Access Compliance Report

Public Rights-of-Way

(Curb Ramps)

Intersection ID: 10257	Main Street: E_36TH_ST	Cross Street: N_MCDOWELL_ST	Location: E
ADA ID: 7287E420BC44	Ramp Type: PerpDiag	Initial Pass/Fail: Fail	Overall Compliance: No
		Severity Score: 12.5	
Codes/Mitigation Info/Possible Solution		Field Measurements/Component Compliance

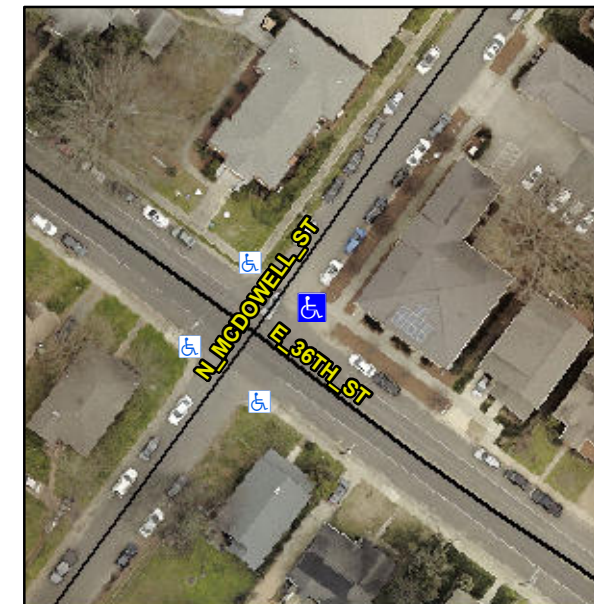
Not Found, R304.5.3

Compliance	Description	Data	Compliance	Description	Data
N/A	Ramp Length (in)	120.0	Yes	Ramp Slope (%)	6.4
Yes	Ramp Width (in)	48.0	No	Ramp XSlope (%)	5.2
N/A	Flare Type LT	N/A	N/A	Flare Type RT	N/A
N/A	Flare Slope LT (%)	N/A	N/A	Flare Slope RT (%)	N/A
N/A	Flare Traversable LT?	N/A	N/A	Flare Traversable RT?	N/A
N/A	Landing Length (in)	N/A	N/A	DWS Provided?	N/A
N/A	Landing Width (in)	N/A	N/A	DWS Contrast?	N/A
N/A	Landing Slope (%)	N/A	N/A	DWS Length (in)	N/A
N/A	Landing X Slope (%)	N/A	N/A	DWS Full Width?	N/A
N/A	Landing Curb? (Y/N)	N/A	N/A	DWS Offset (in)	N/A
N/A	Shared Landing?	N/A			
N/A	Gutter Ponding?	Yes	N/A	Gutter Slope (%)	N/A
N/A	Gutter Lip Ht (in)	0.5	N/A	Gutter X Slope (%)	N/A
N/A	Painted X Walk1?	No	N/A	Painted X Walk2?	No
	X Walk 1 Direction	To NW		X Walk 2 Direction	To SW
N/A	X Walk 1 Width (in)	N/A	N/A	X Walk 2 Width (in)	N/A
	X Walk 1 Slope (%)	0.1		X Walk 2 Slope (%)	2.5
	X Walk 1 X Slope (%)	2.7		X Walk 2 X Slope (%)	0.2

Remove & Replace Curb Ramp With Two New Directional Ramps or Equivalent.
